THE VILLAGE AT TOTEM LAKE: MIXED USED DEVELOPMENT / KIRKLAND, WASHINGTON
DESIGN REVIEW BOARD, MINOR MODIFICATIONS

BUILDING A - ROOF PLAN
PRESENTED 01/04/2016

BUILDING A - NEW ROOF PLAN

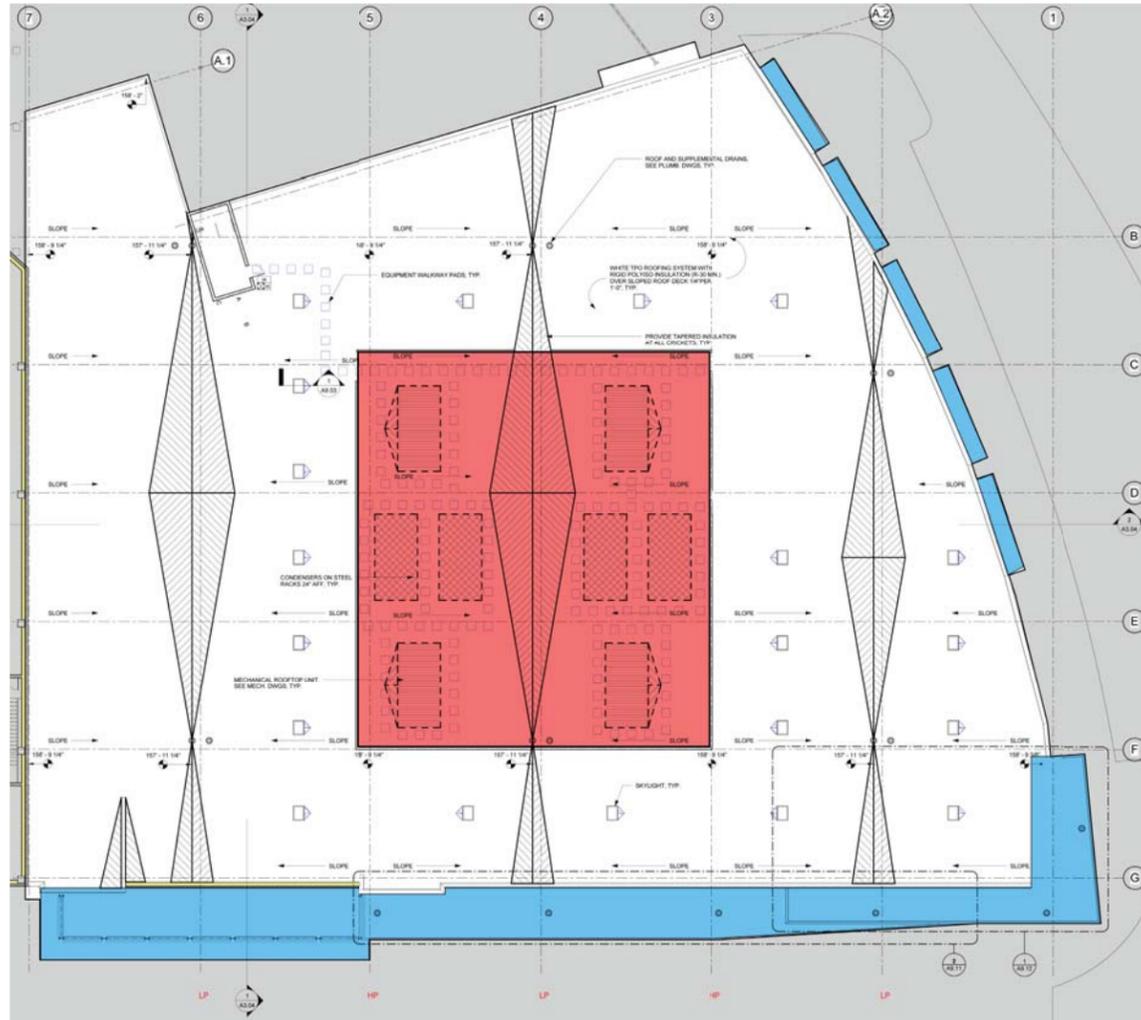
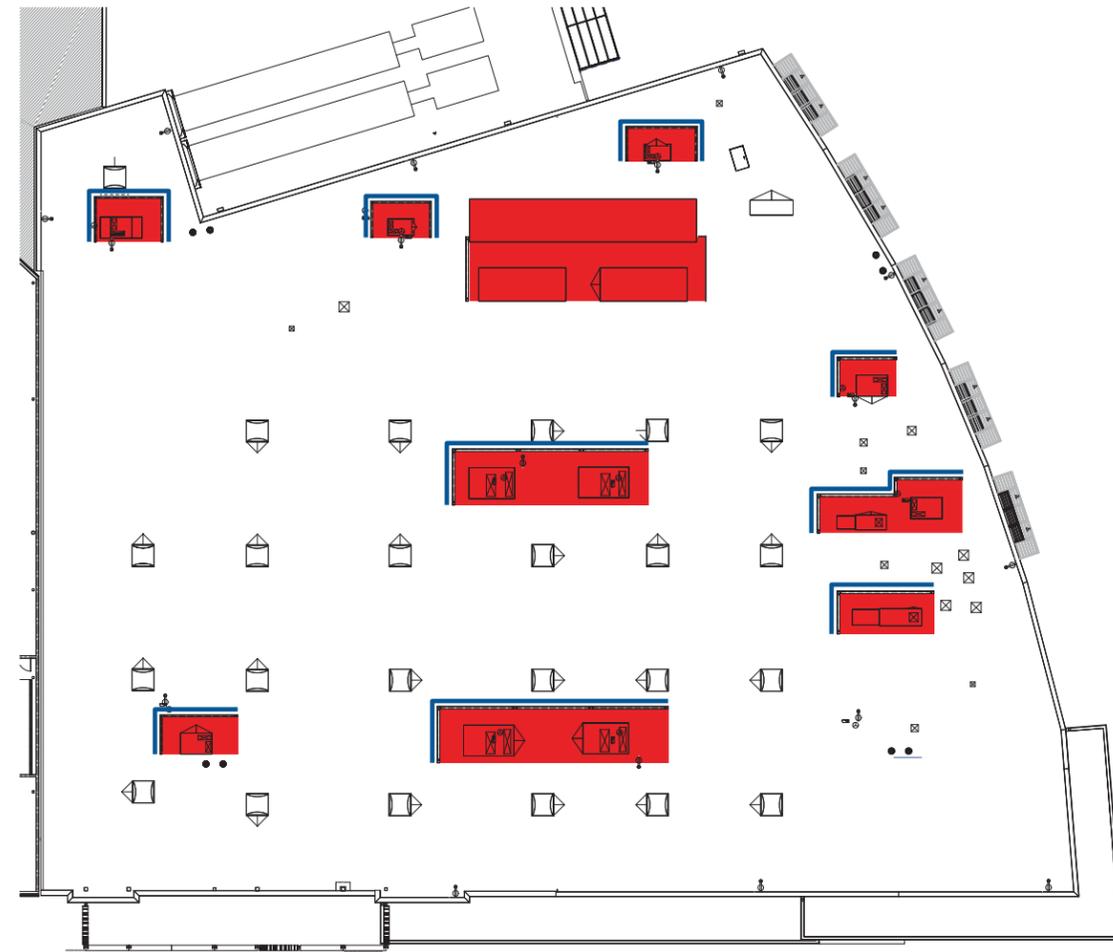
- 1. ROOFTOP MECHANICAL EQUIPMENT MOVED:**
 EQUIPMENT REDISTRIBUTED TO BETTER CONICIDE WITH THE AREAS OF THE STORE THEY SERVE.
- 2. CENTRAL MECHANICAL SCREEN CHANGED TO INDIVIDUAL SCREENED AREAS:**
 ORIGINAL SCREEN DESIGN DID NOT PROPERLY SCREEN THE EQUIPMENT FROM RESIDENTIAL BUILDINGS TO THE NORTH AND THE UPPER MALL.
- 3. SCREEN MATERIAL & COLOR.**
 CORRUGATED METAL PANEL: GREY

BUILDING A - SECTION A

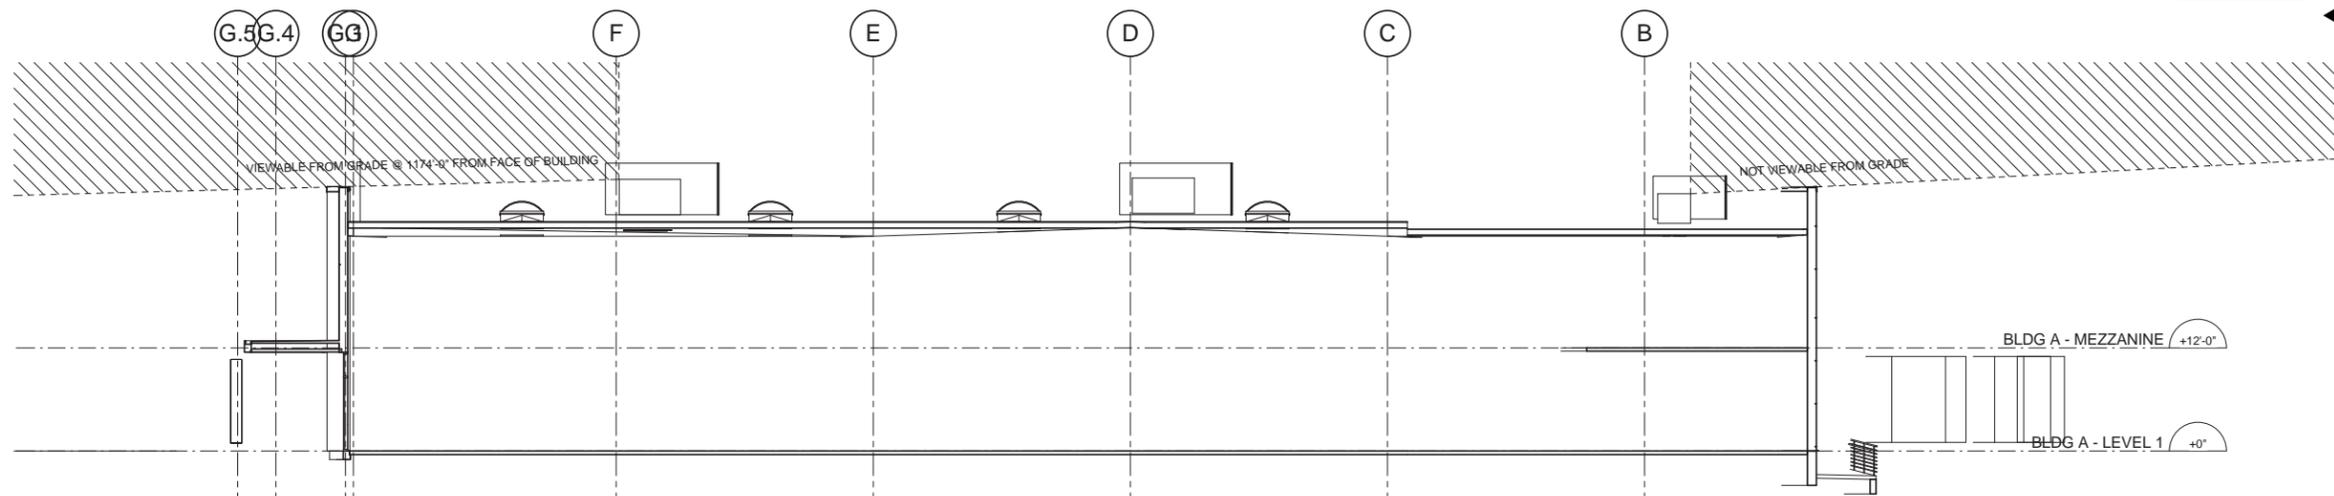
- 1. ROOFTOP MECHANICAL EQUIPMENT MOVED:**
EQUIPMENT REDISTRIBUTED TO BETTER CONICIDE WITH THE AREAS OF THE STORE THEY SERVE.
- 2. CENTRAL MECHANICAL SCREEN CHANGED TO INDIVIDUAL SCREENED AREAS:**
ORIGINAL SCREEN DESIGN DID NOT PROPERLY SCREEN THE EQUIPMENT FROM RESIDENTIAL BUILDINGS TO THE NORTH AND THE UPPER MALL.
- 3. SCREEN MATERIAL & COLOR.**
CORRUGATED METAL PANEL: GREY
- 4. THERE IS NO SIMILAR VIEW FROM THE EXISTING DRB SUBMITTALS.**

BUILDING A - SECTION B

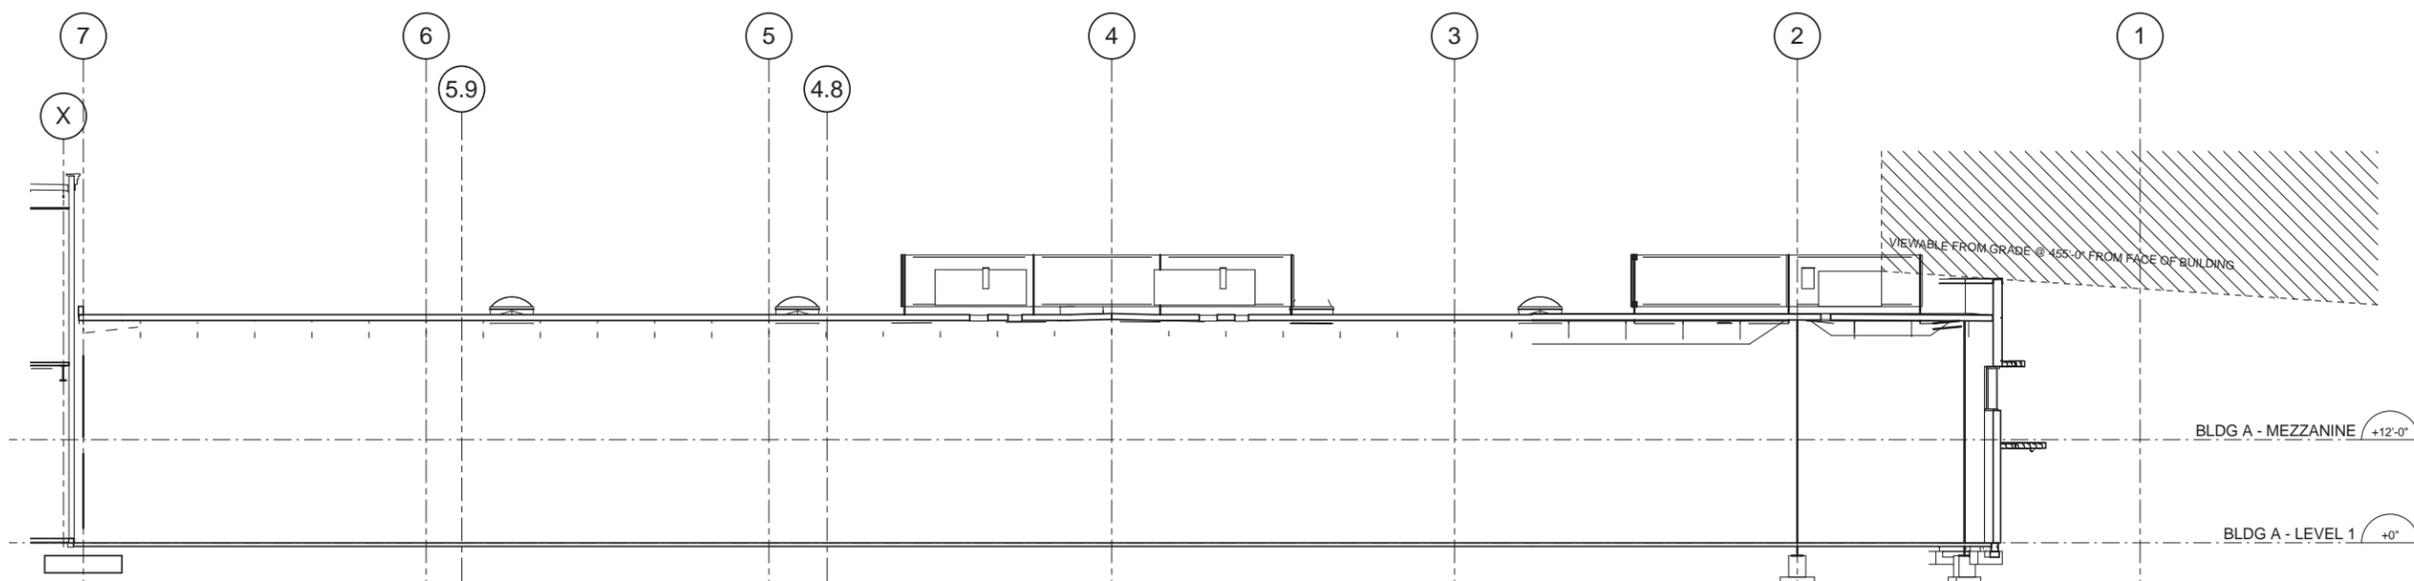
- 1. ROOFTOP MECHANICAL EQUIPMENT MOVED:**
EQUIPMENT REDISTRIBUTED TO BETTER CONICIDE WITH THE AREAS OF THE STORE THEY SERVE.
- 2. CENTRAL MECHANICAL SCREEN CHANGED TO INDIVIDUAL SCREENED AREAS:**
ORIGINAL SCREEN DESIGN DID NOT PROPERLY SCREEN THE EQUIPMENT FROM RESIDENTIAL BUILDINGS TO THE NORTH AND THE UPPER MALL.
- 3. SCREEN MATERIAL & COLOR.**
CORRUGATED METAL PANEL: GREY
- 4. THERE IS NO SIMILAR VIEW FROM THE EXISTING DRB SUBMITTALS.**

BUILDING A - ELEVATED VIEW (75' ABOVE FINISH GRADE @ BUILDING A) FROM UPPER MALL

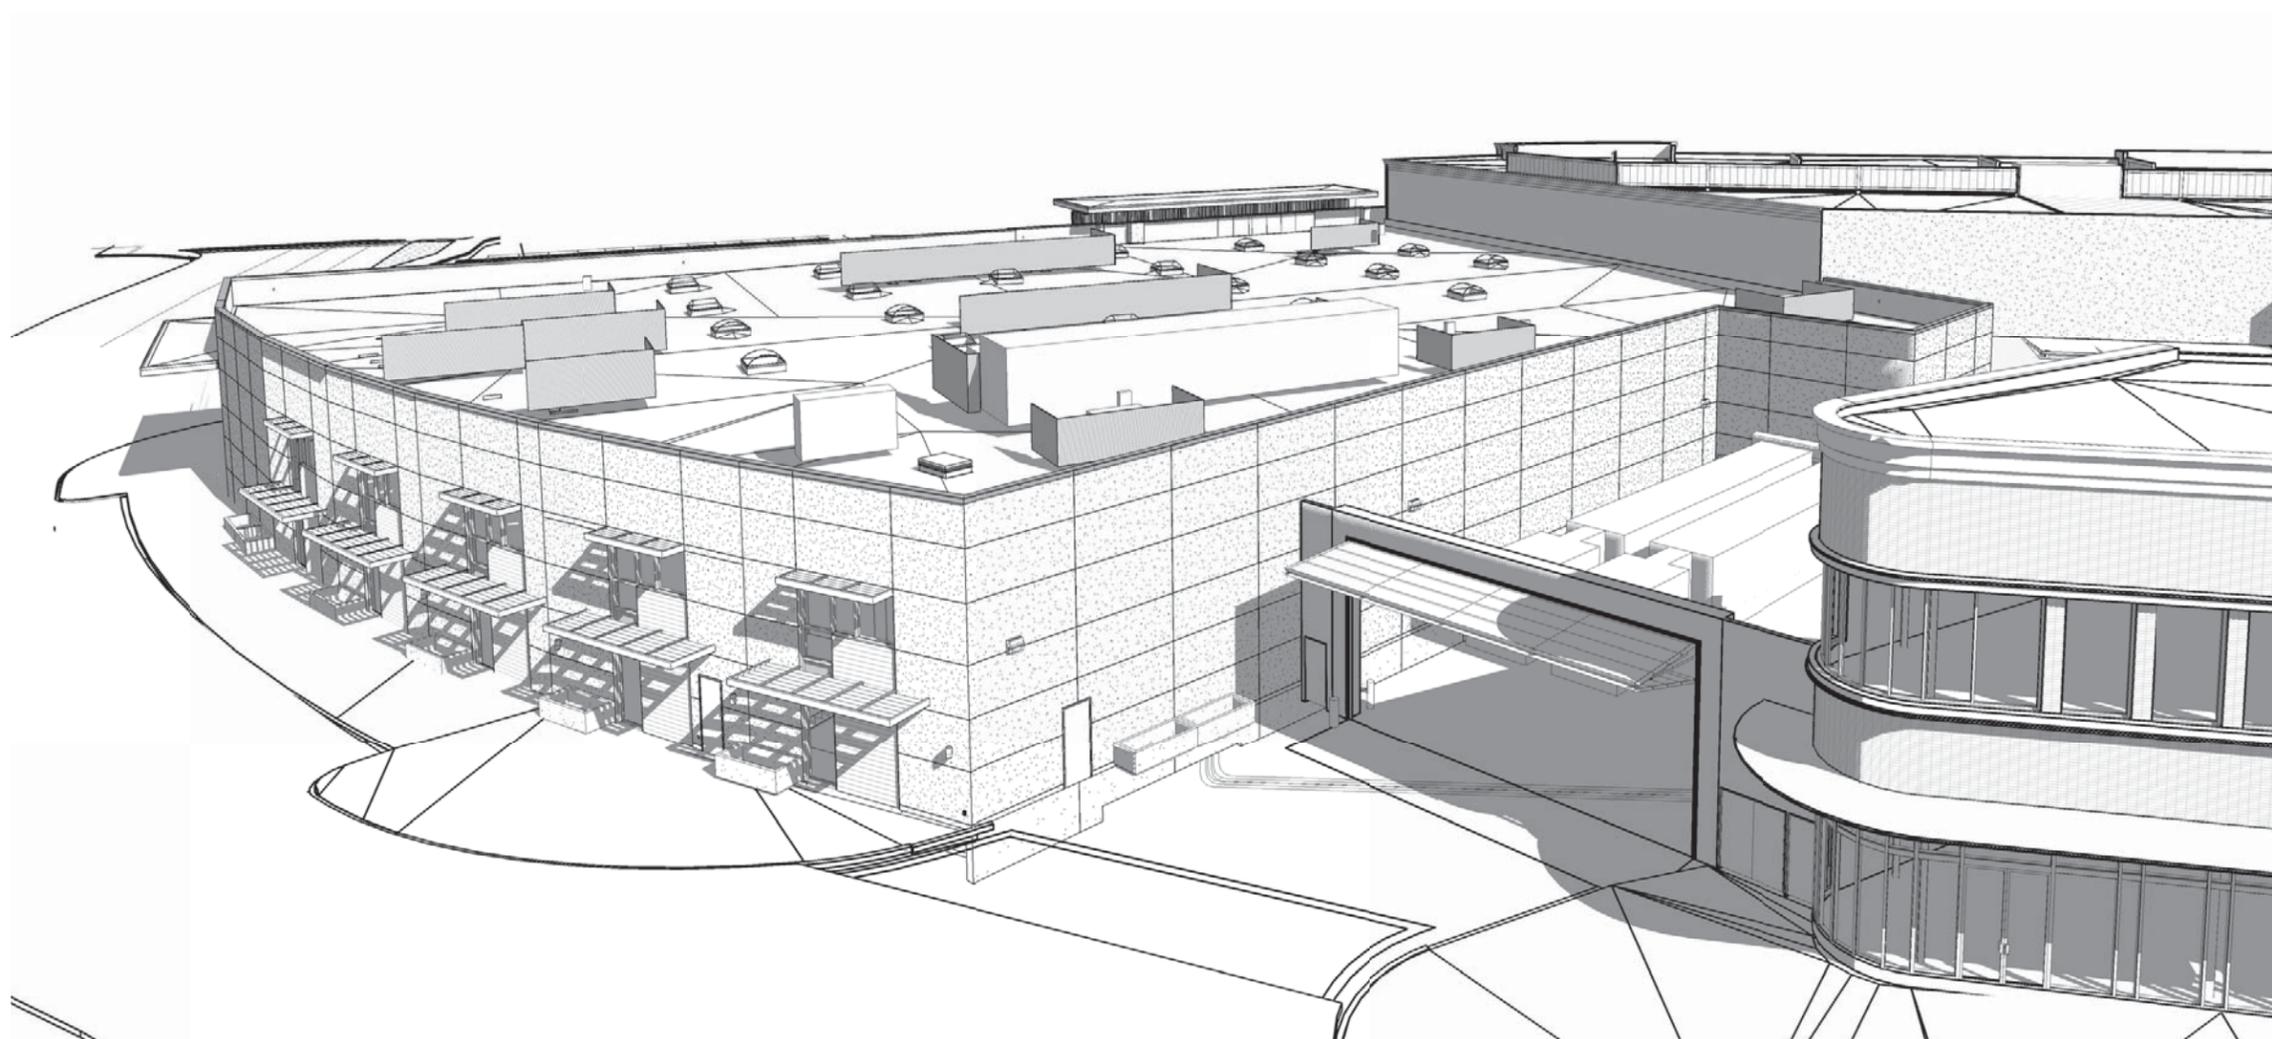
- 1. ROOFTOP MECHANICAL EQUIPMENT MOVED:**
EQUIPMENT REDISTRIBUTED TO BETTER CONICIDE WITH THE AREAS OF THE STORE THEY SERVE.
- 2. CENTRAL MECHANICAL SCREEN CHANGED TO INDIVIDUAL SCREENED AREAS:**
ORIGINAL SCREEN DESIGN DID NOT PROPERLY SCREEN THE EQUIPMENT FROM RESIDENTIAL BUILDINGS TO THE NORTH AND THE UPPER MALL.
- 3. SCREEN MATERIAL & COLOR.**
CORRUGATED METAL PANEL: GREY
- 4. THERE IS NO SIMILAR VIEW FROM THE EXISTING DRB SUBMITTALS.**

BUILDING A - VIEW FROM GROUND LEVEL @ BUILDING "K" PARKING LOT DRIVEWAY

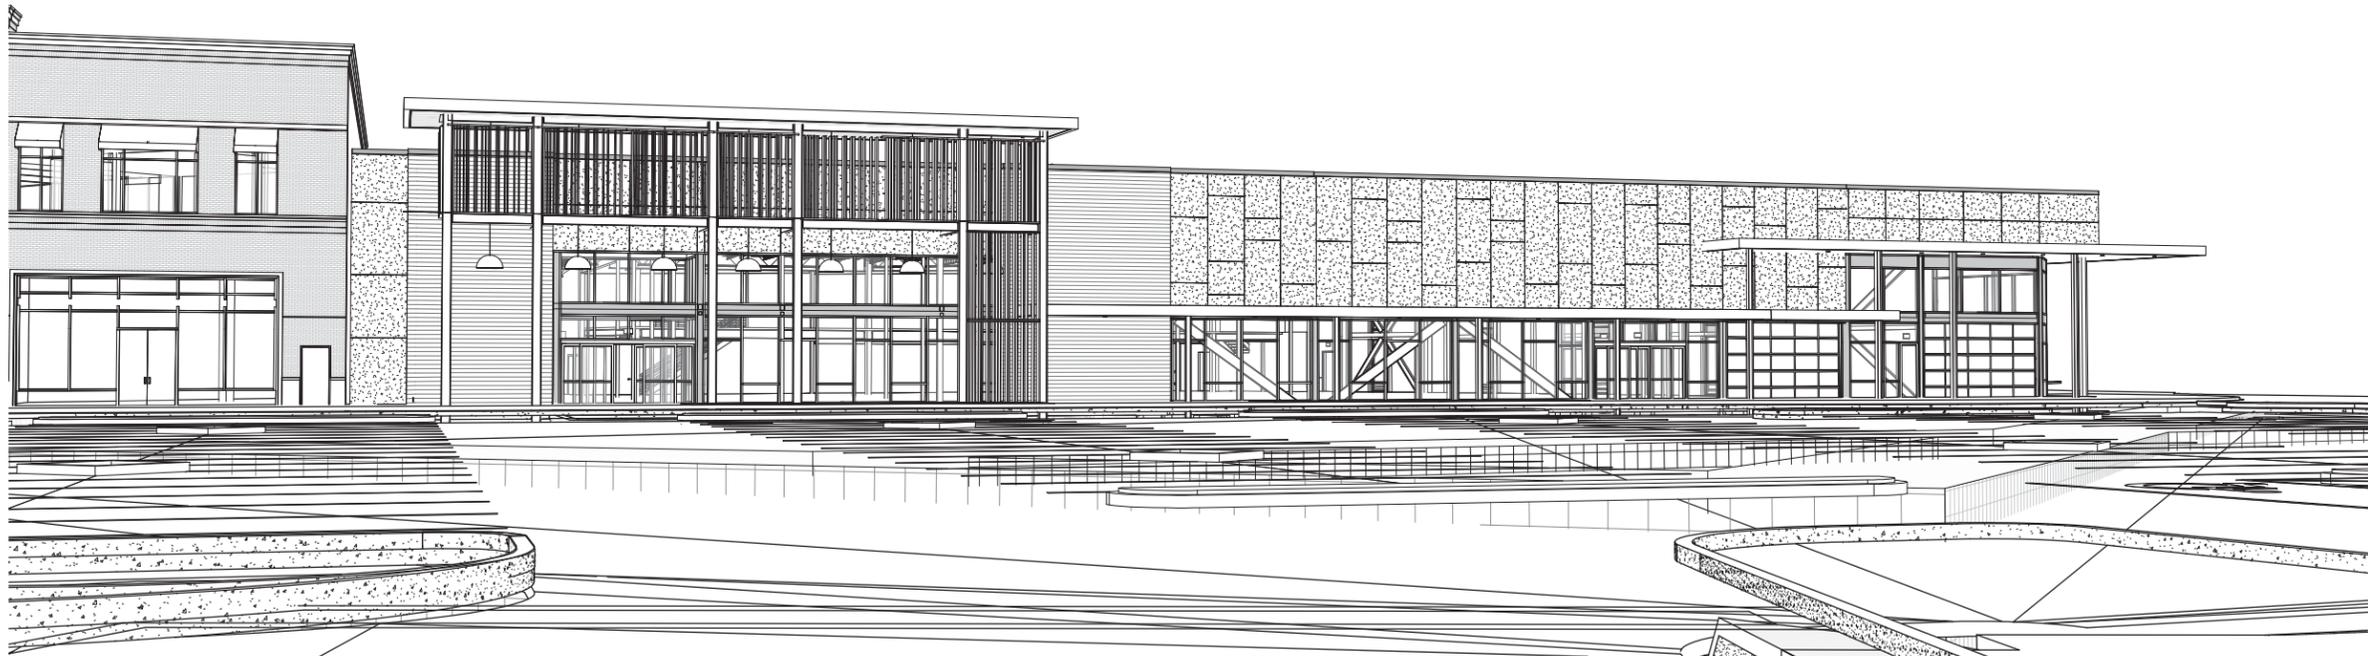
- 1. ROOFTOP MECHANICAL EQUIPMENT MOVED:**
EQUIPMENT REDISTRIBUTED TO BETTER CONICIDE WITH THE AREAS OF THE STORE THEY SERVE.
- 2. CENTRAL MECHANICAL SCREEN CHANGED TO INDIVIDUAL SCREENED AREAS:**
ORIGINAL SCREEN DESIGN DID NOT PROPERLY SCREEN THE EQUIPMENT FROM RESIDENTIAL BUILDINGS TO THE NORTH AND THE UPPER MALL.
- 3. SCREEN MATERIAL & COLOR.**
CORRUGATED METAL PANEL: GREY
- 4. THERE IS NO SIMILAR VIEW FROM THE EXISTING DRB SUBMITTALS.**

BUILDING A - NEW PLAN FOR SOUTH CORNER

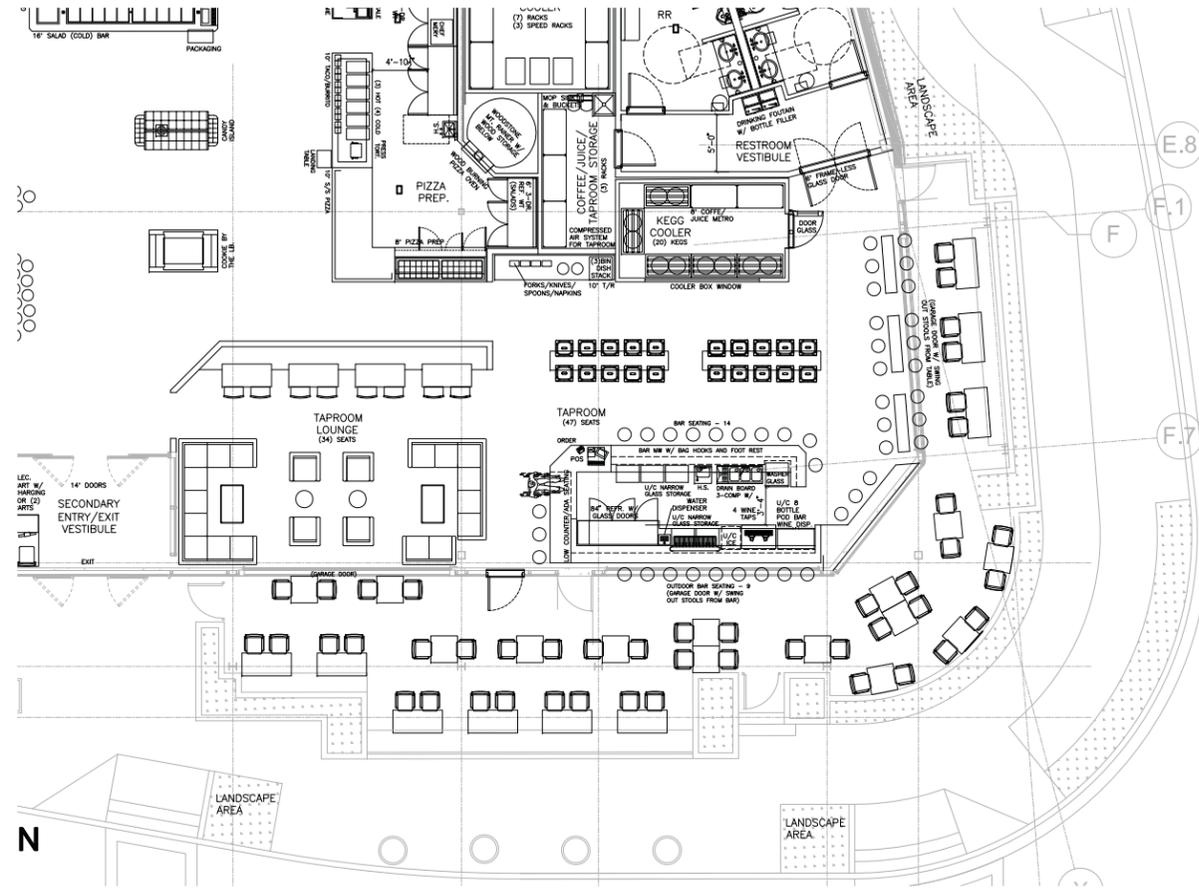
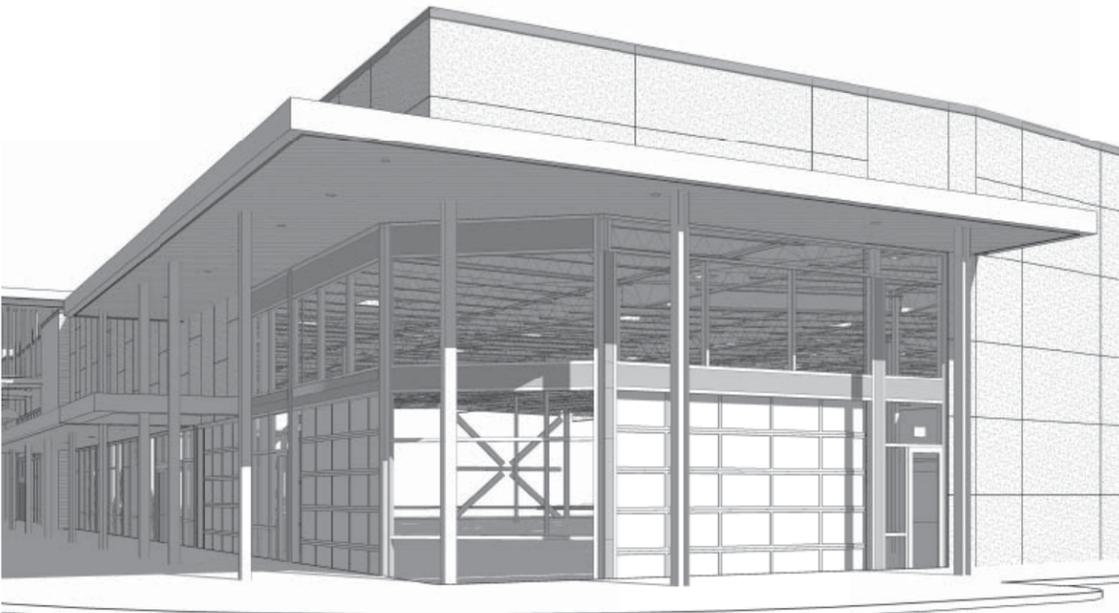
- 1. CHAMFERED CORNER AT THE EATING AREA**
 TO PROVIDE GREATER DEPTH FOR PATIO SEATING LAYOUT WHILE MAINTAINING EXISTING PATHWAY WIDTH.
